SUBJECT: **Case 18276: Union Street Public Participation Committee Report**

1. Reject the proposed residential development by KWR Approvals Incorporated to enable a residential development at 74 Union Street, Bedford.

KWR Approvals Incorporated applied to consider a residential development at 74 Union Street in Bedford by development agreement. This property is part of the Residential Comprehensive Development Districts (RCDD) lands and is eligible for consideration of residential, institutional, parks, recreational and limited neighbourhood commercial uses by development agreement.

**UNION COURTYARD
OPTION A**

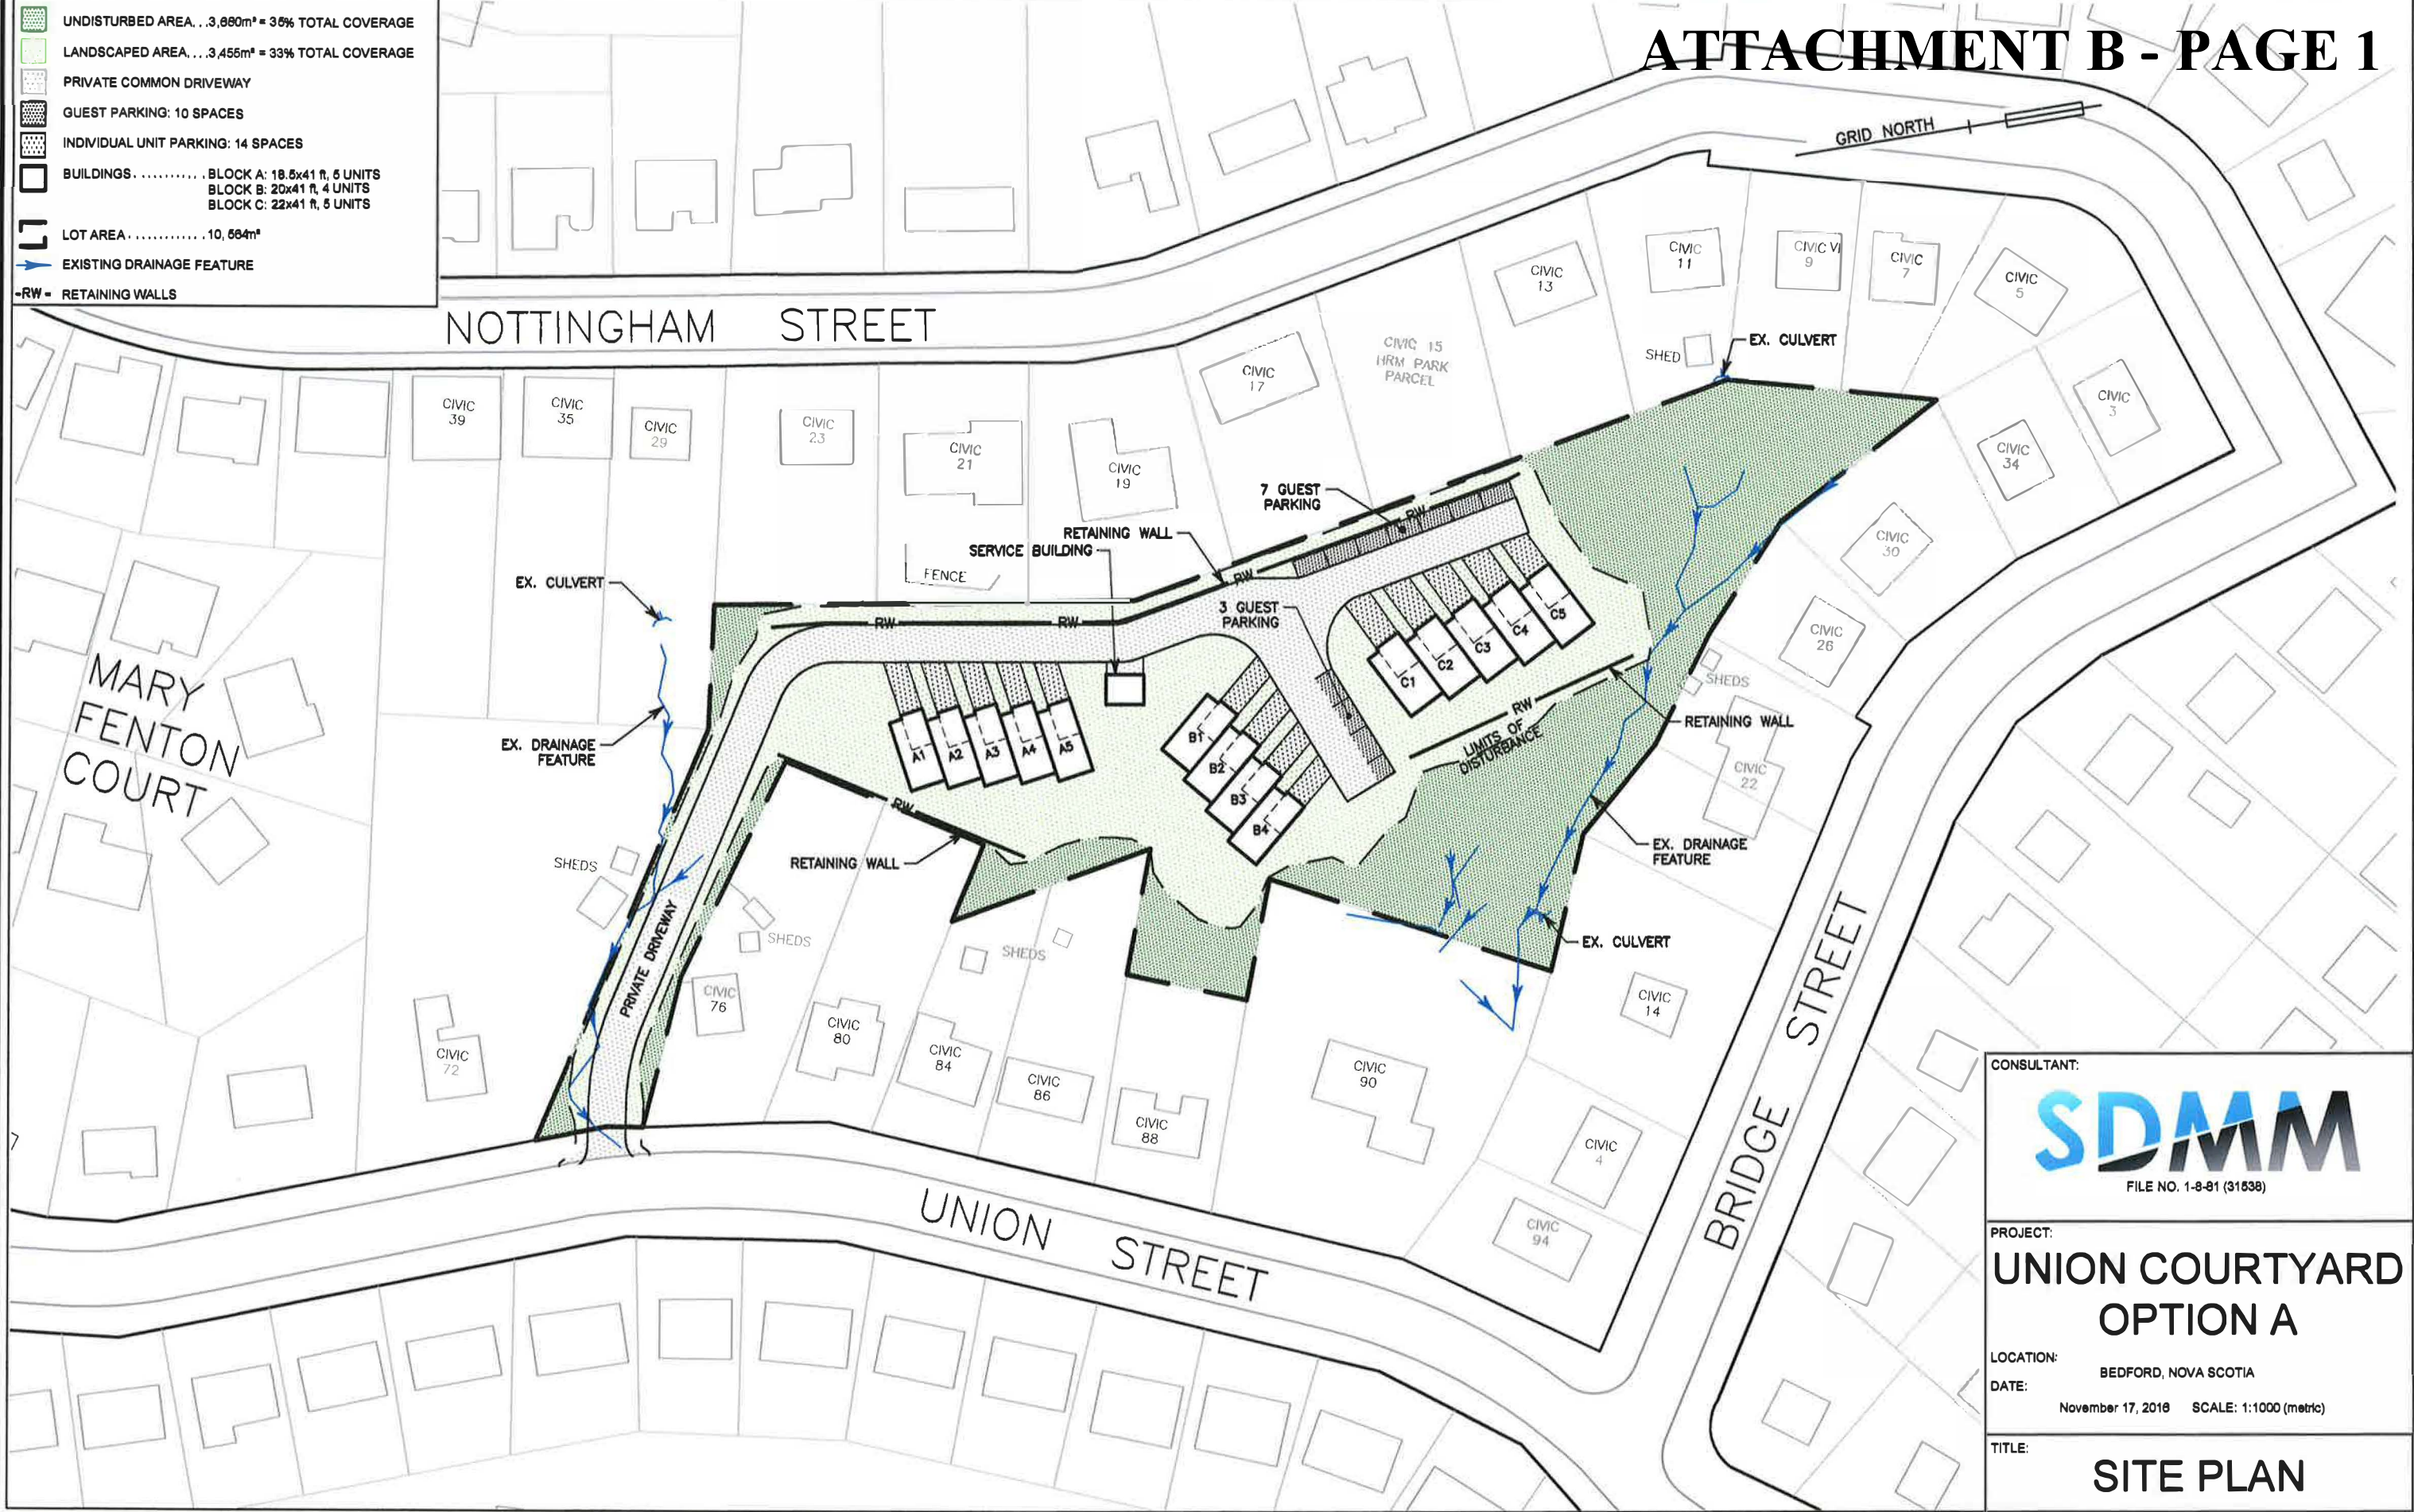
Although PPC recommends against the proposal, Council may choose to consider the proposed townhouse development and schedule a public hearing. PPC voted on their preferred design option (see Attachments B and C). There was a tied vote: two members voted in favour of Option A, two members voted in favour of Option B, and two members were neutral. If the development proposal proceeds, PPC recommends including provisions in the development agreement to address the following concerns:

PPC acknowledges the proponent's efforts to improve the architectural design by incorporating more traditional materials, pitched roofs, and decorative features that complement the established residential neighbourhood. However, PPC feels further improvements could be made to the design of the townhouses. Incorporating more variety in the facades would make the units appear like separate dwellings. Each townhouse unit should have a distinctive design, yet be compatible with the overall development and surrounding residential community. Additionally, Policy R-12A suggests locating garage entrances to the side of dwellings and setback from the front façade. PPC advises that locating garage entrances along the side rather than the front of the townhouses would better meet Policy R-12A, but may present issues with snow removal.

PPC expressed concern about privacy, noise and light pollution from vehicles on the subject property. Additional plantings along the property boundaries, and between the proposed driveway and abutting houses, would minimise the impact of the proposed development on the existing neighbourhood. There is concern that young trees and shrubs would not provide adequate buffering; the caliper of trees and tree species that provide year-round screening should be required under the agreement. PPC recommends establishing a non-disturbance area to maximise tree retention and to ensure there is appropriate buffering from the abutting residences. A larger non-disturbance area around the entire site was suggested. PPC would also like to see additional landscaping between the proposed development and civic numbers 72 and 76 Union Street. Establishing a time limit to implement the landscaping plan was also suggested.

Policy E-4 prohibits the development of townhouses within 50 feet of a watercourse, except by development agreement. If the drainage features are deemed watercourses, additional setbacks and buffering should be provided. PPC is concerned that the removal of vegetation in proximity to these drainage channels would increase flooding on adjacent properties. In response to PPC's concerns, the applicant has shown a non-

disturbance area and buffer around the drainage channel on the eastern portion of the site, but PPC is not confident the buffer is sufficient to protect the development and surrounding homes from flooding. Likewise, PPC feels there is inadequate buffering around the drainage feature along the western property boundary to protect abutting properties from flooding. See Policy E-4 of Attachment D for further details. PPC requests that measurements are provided on the site and landscaping plans attached to the proposed development agreement.
